**METROPOLITAN GOVERNMENT OF NASHVILLE AND DAVIDSON COUNTY**

**STAFF RECOMMENDATION**  
**1914 20<sup>th</sup> Avenue South**  
**September 16, 2015**

**Application:** New construction—Addition; Setback determination  
**District:** Belmont-Hillsboro Neighborhood Conservation Zoning Overlay  
**Council District:** 18  
**Map and Parcel Number:** 10412013300  
**Applicant:** Mitchell Barnett  
**Project Lead:** Melissa Baldock, melissa.baldock@nashville.gov

| <p><b>Description of Project:</b> The application is to construct a rear addition that requires a setback determination. The existing structure is non-contributing.</p> <p><b>Recommendation Summary:</b> Staff recommends approval of the application with the following conditions:</p> <ol style="list-style-type: none"> <li>1. Staff approve the final details, dimensions and materials of windows, doors, canopies, and railings prior to purchase and installation; and,</li> <li>2. Staff approve the location of the HVAC unit.</li> </ol> <p>With these conditions, staff finds that the proposed addition and setback determination meets Section II.B. of the <i>Belmont-Hillsboro Neighborhood Conservation Zoning Overlay: Handbook and Design

Figure 1. 1914 20<sup>th</sup> Avenue South

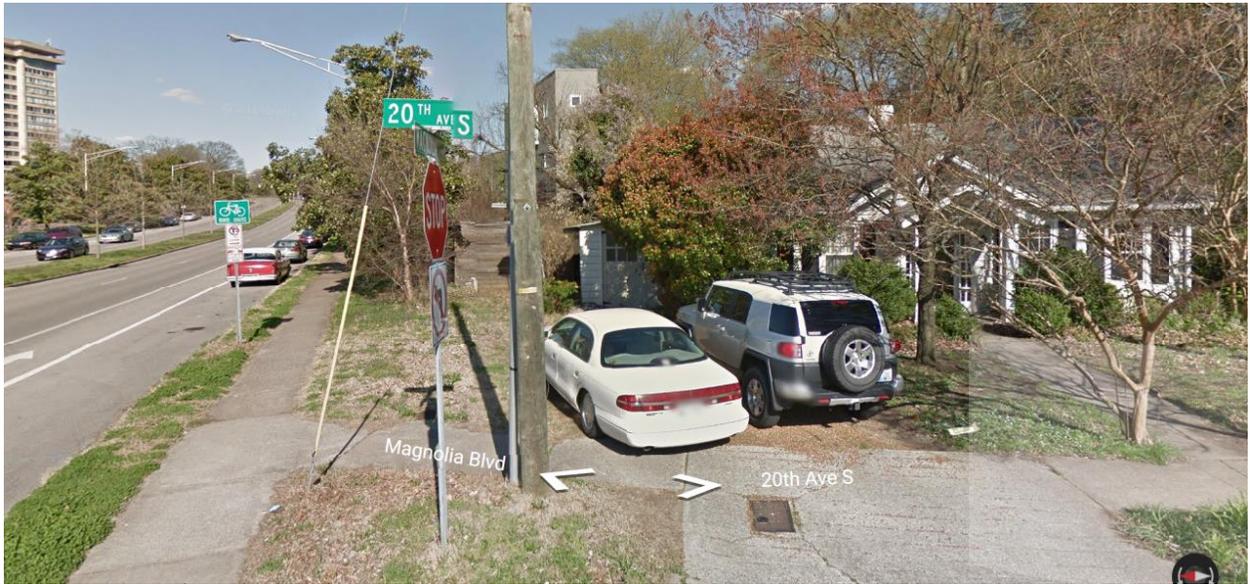
**Background:** 1914 20<sup>th</sup> Avenue South was constructed in 2005 on an unusual triangular-shaped lot (Figure 1). It is a three story, stuccoed house with a flat roof. The house's date of construction, height, roof form, materials, and lack of architectural details do not contribute to the historic character of the Belmont-Hillsboro Neighborhood Conservation Zoning Overlay. The house is only minimally visible from 20<sup>th</sup> Avenue South. It is most visible from across Magnolia Boulevard.

# Enlarged Site Plan

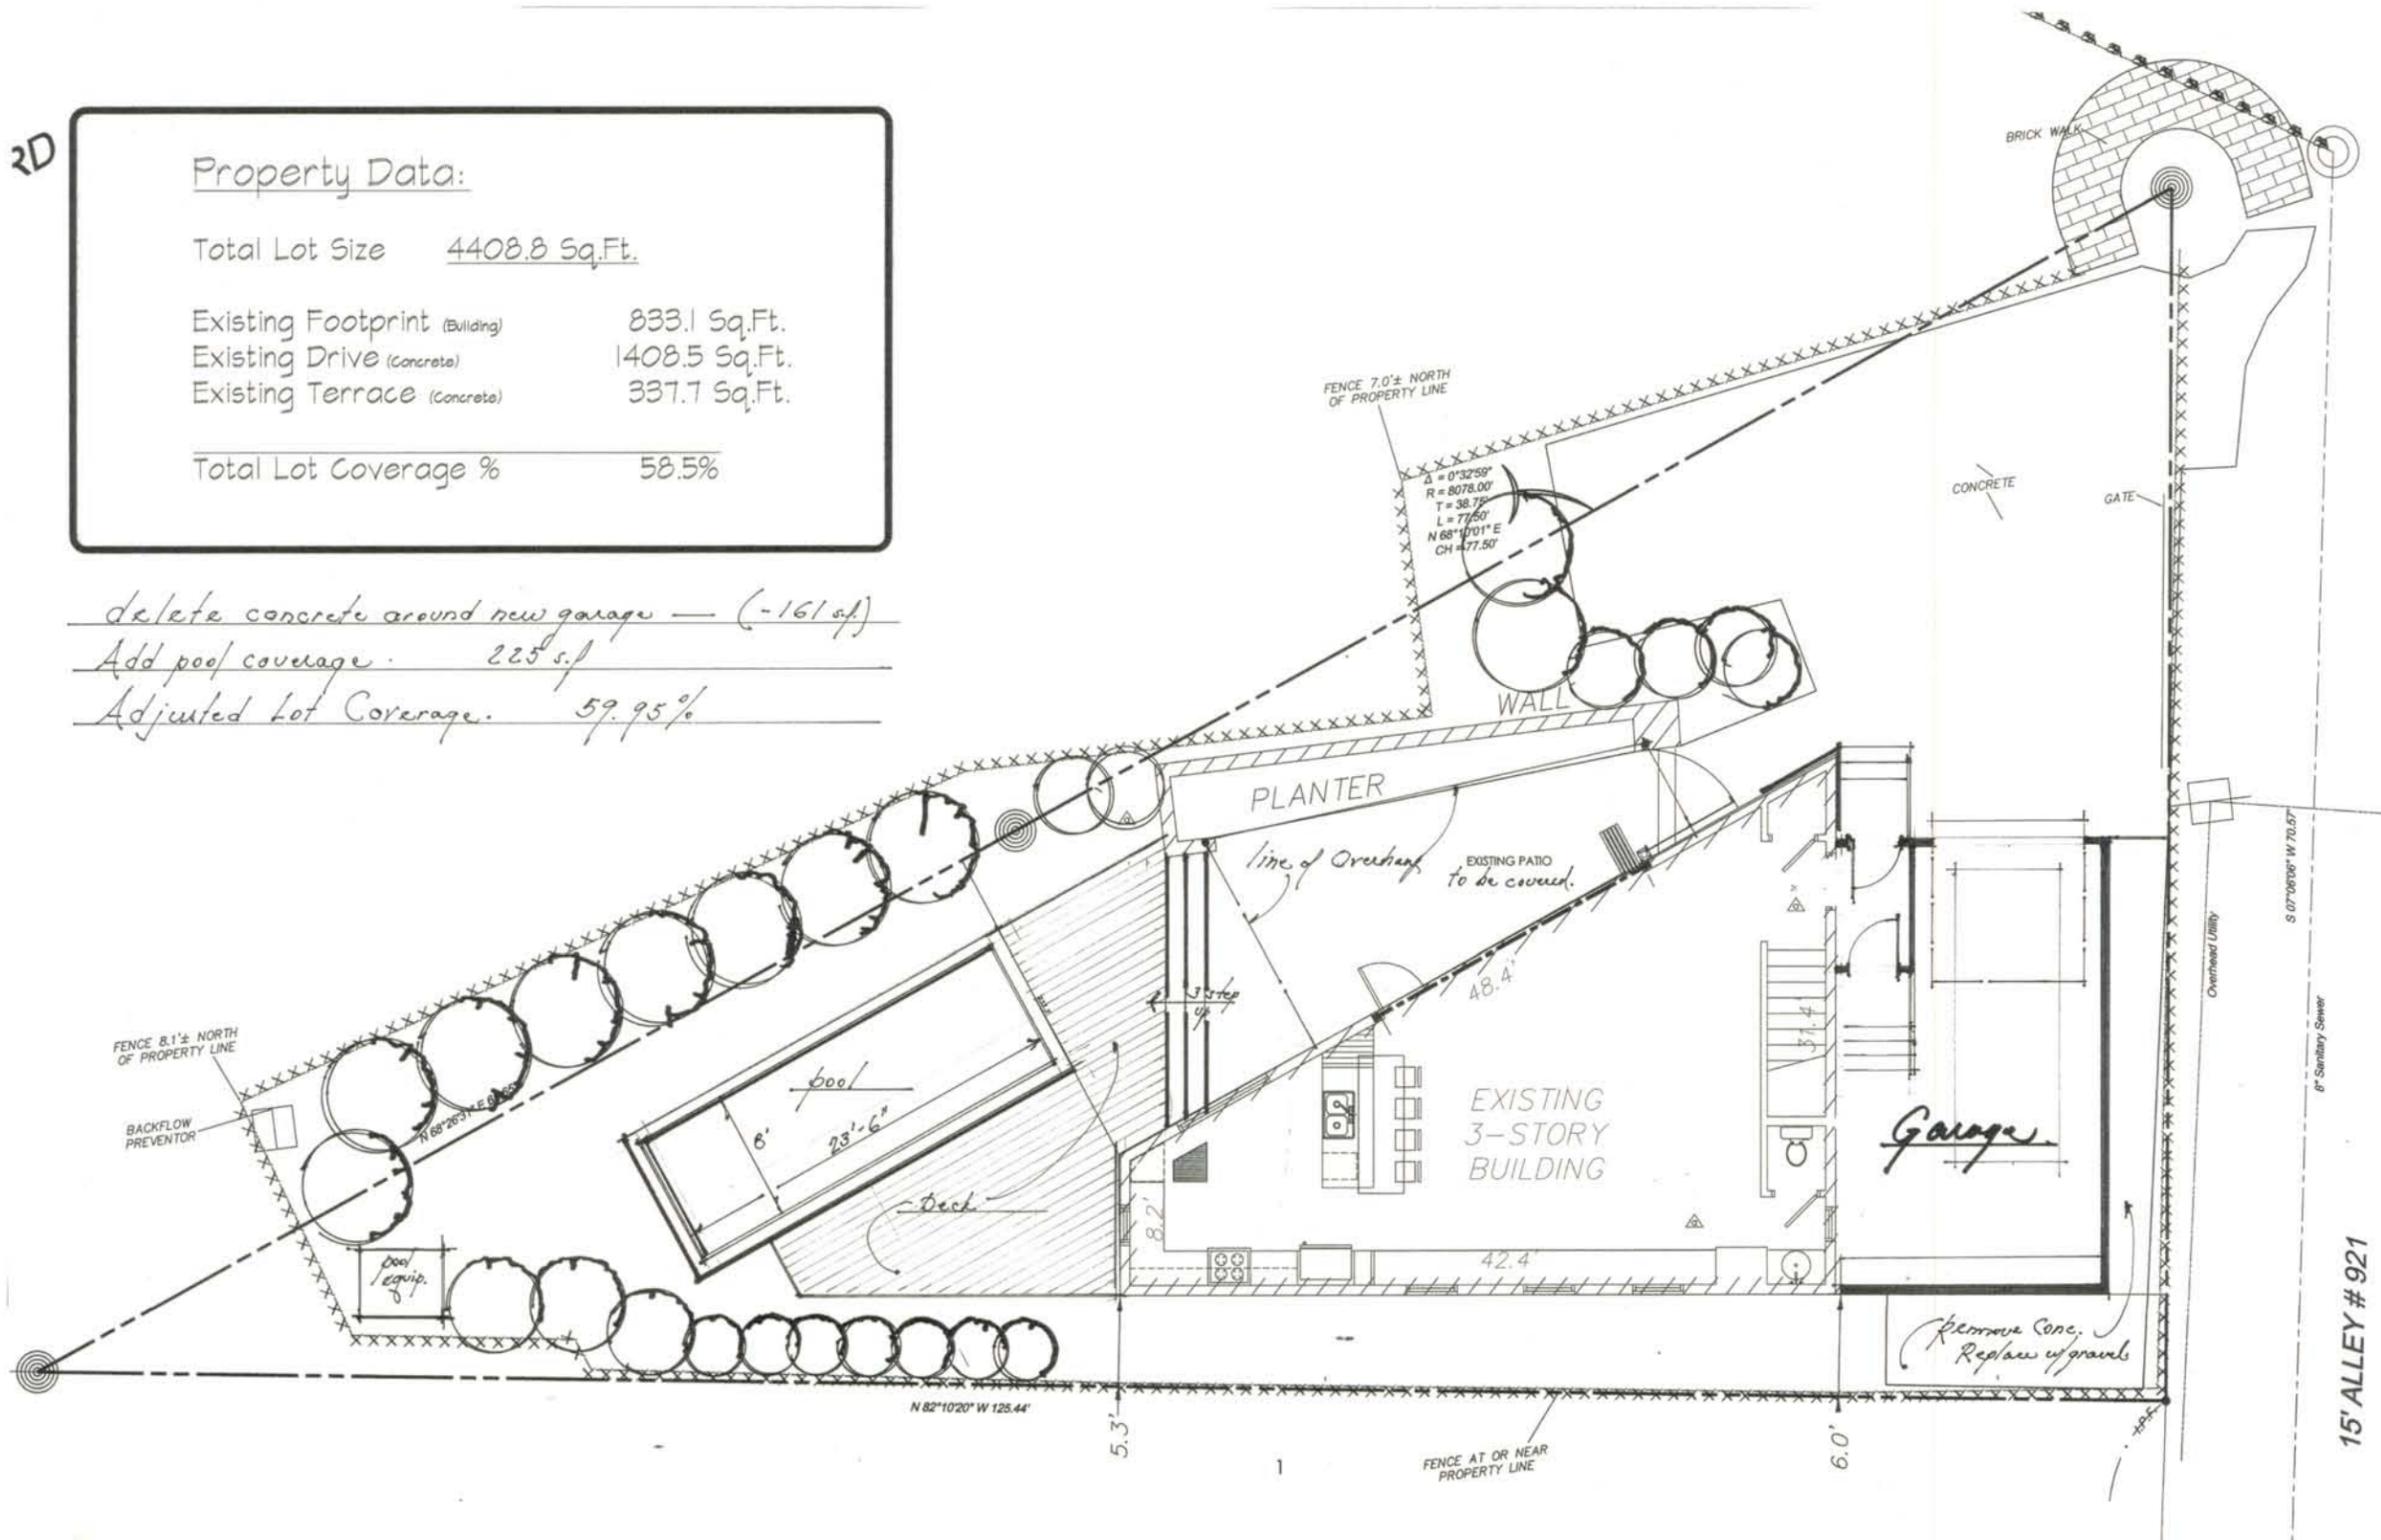
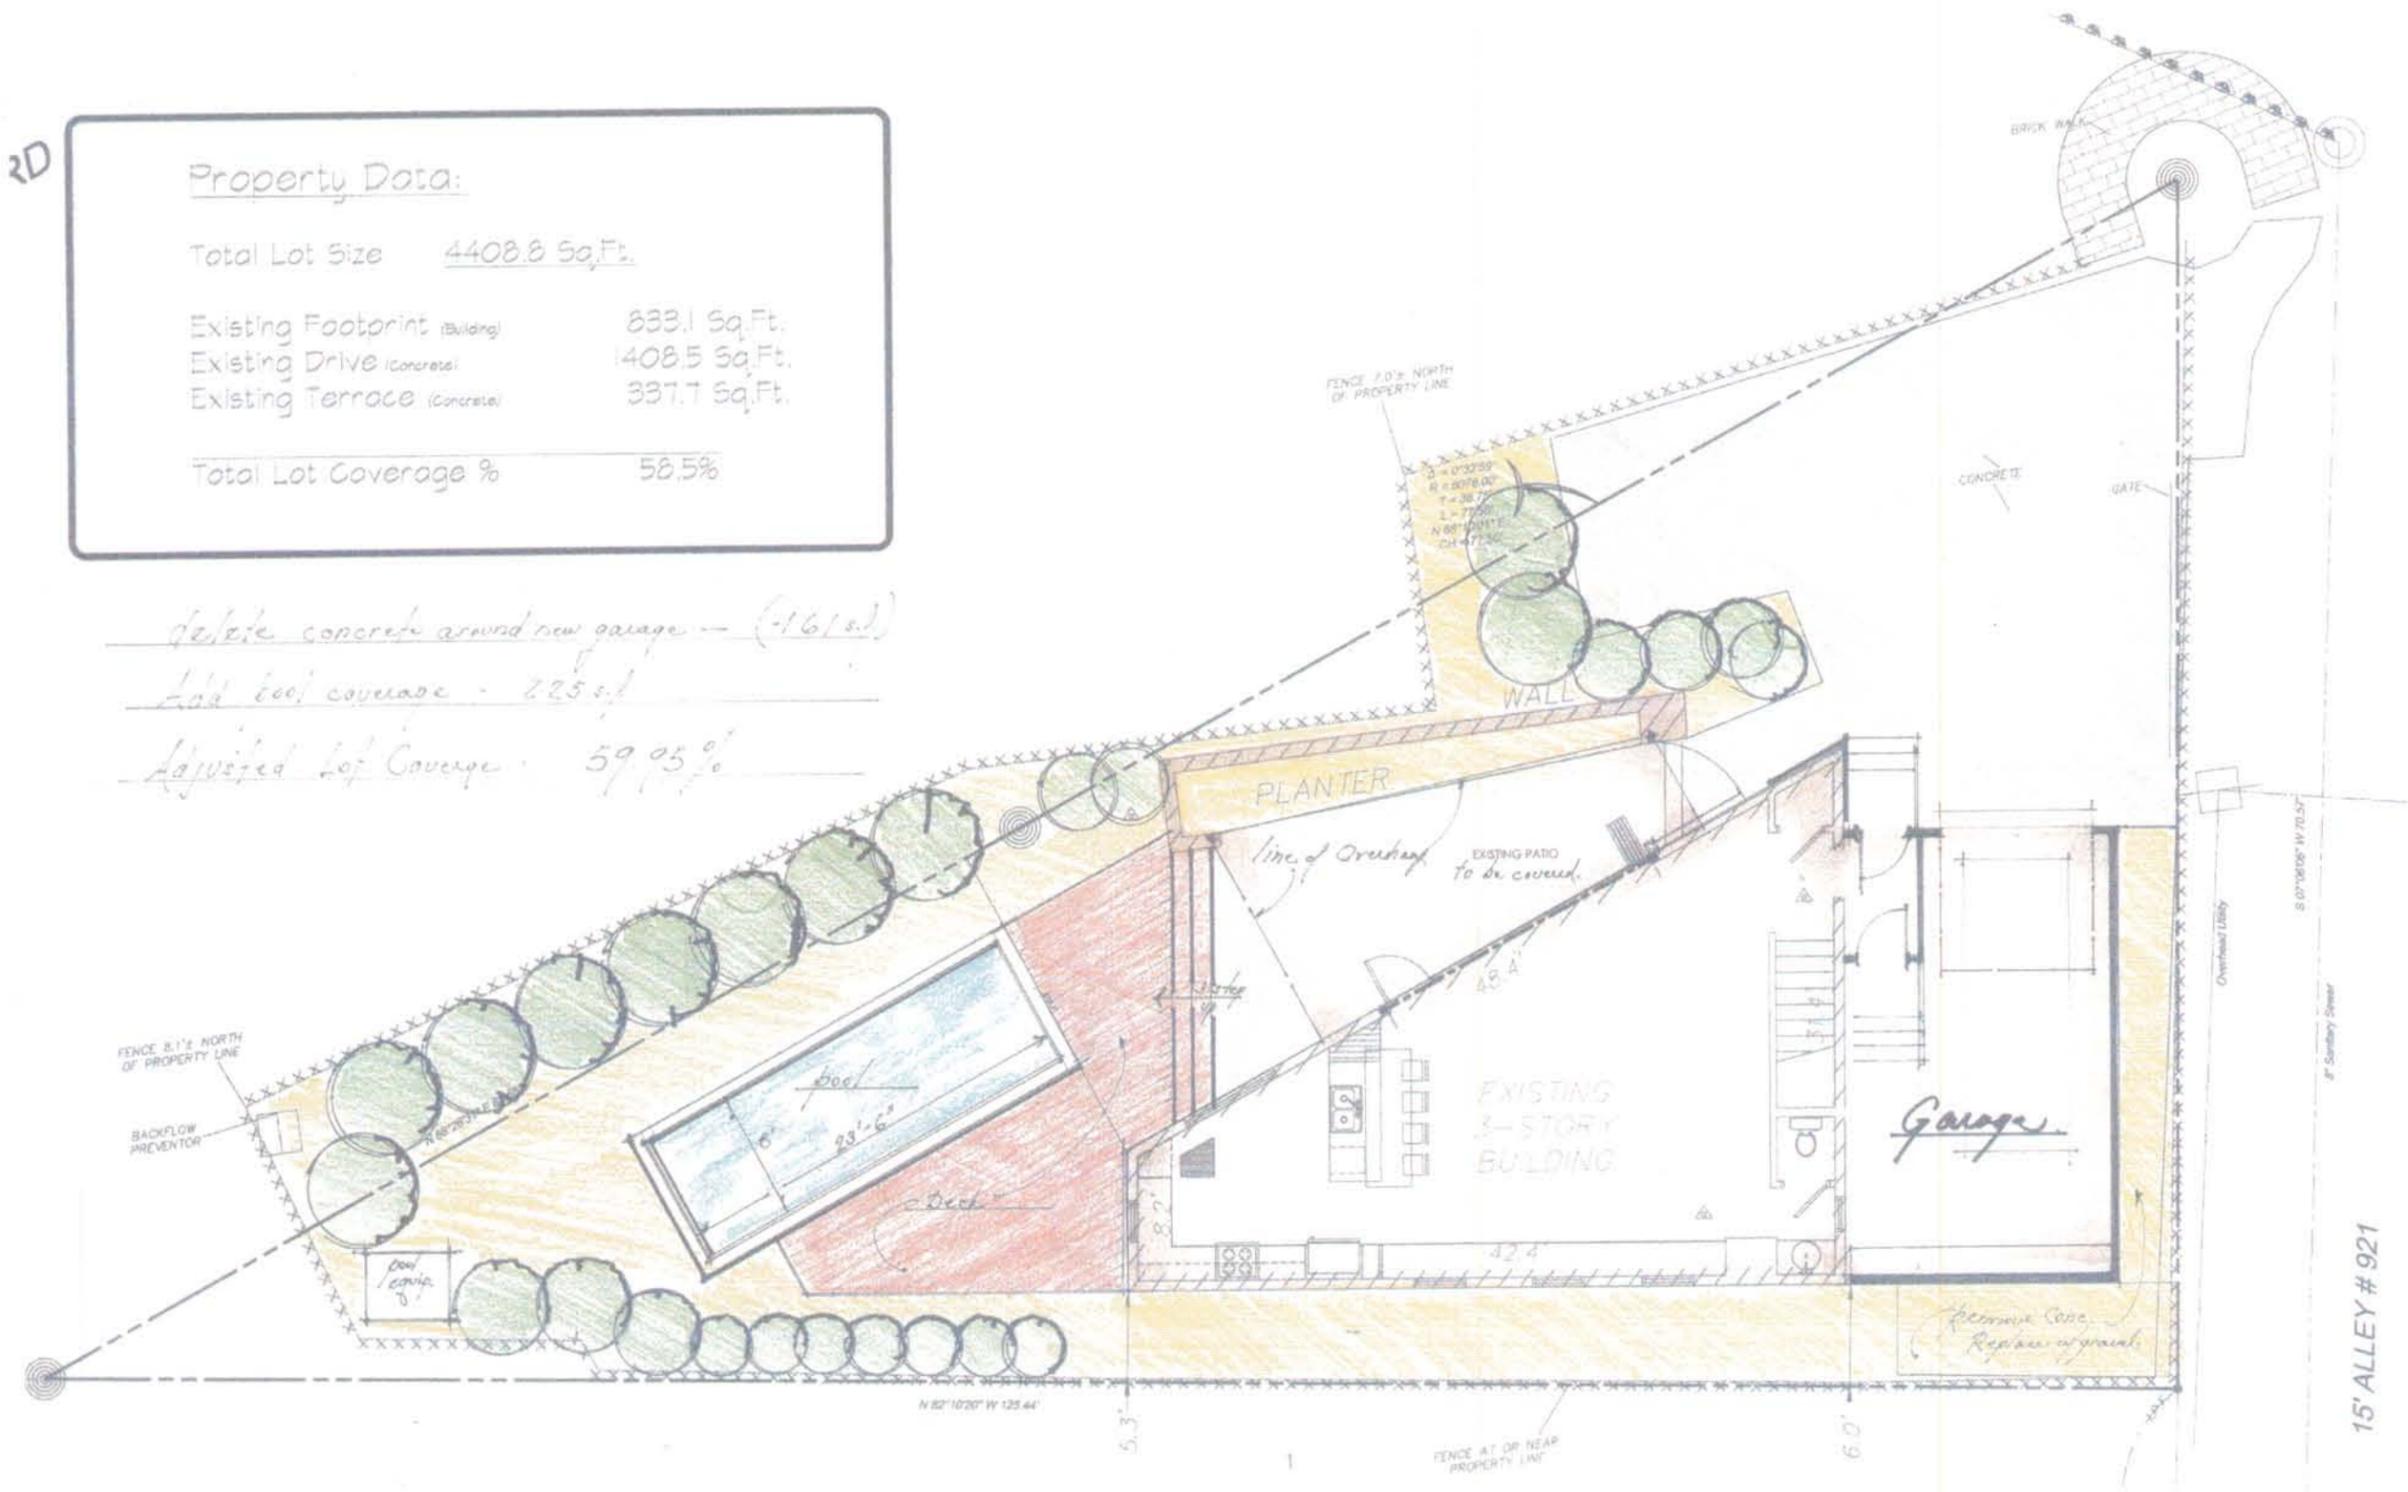
Setback & Rhythm of Spacing: The proposed addition requires a setback determination. The two-story portion of the addition will be situated a minimum of three feet (3') from the rear property line. Base zoning requires a setback of twenty feet (20'). Staff finds the proposed rear setback to be appropriate for several reasons. The lot's unusual triangular shape constrains the size and location of the house and any additions. In addition, the house on the lot is not historic, and does not address either the 20<sup>th</sup> Avenue South or the Magnolia Boulevard streetscape. Changing the setbacks does not affect the historic rhythm of spacing for the district. Accessory structures that do not have garage doors facing the alley are permitted to be three feet (3') from the rear property line, and staff finds that the three foot (3') alley setback for the two-story addition, which contains a garage, is appropriate. The roof for the open, covered patio will be between five feet and fourteen feet (5' - 14') from the Magnolia Boulevard property line, and staff finds this setback to be appropriate. Staff finds that the project's setbacks and rhythm of spacing meet Sections II.B.1.c. and II.B.2. of the design guidelines.

1. Staff approve the final details, dimensions and materials of windows, doors, canopies, and railings prior to purchase and installation; and,
2. Staff approve the location of the HVAC unit.
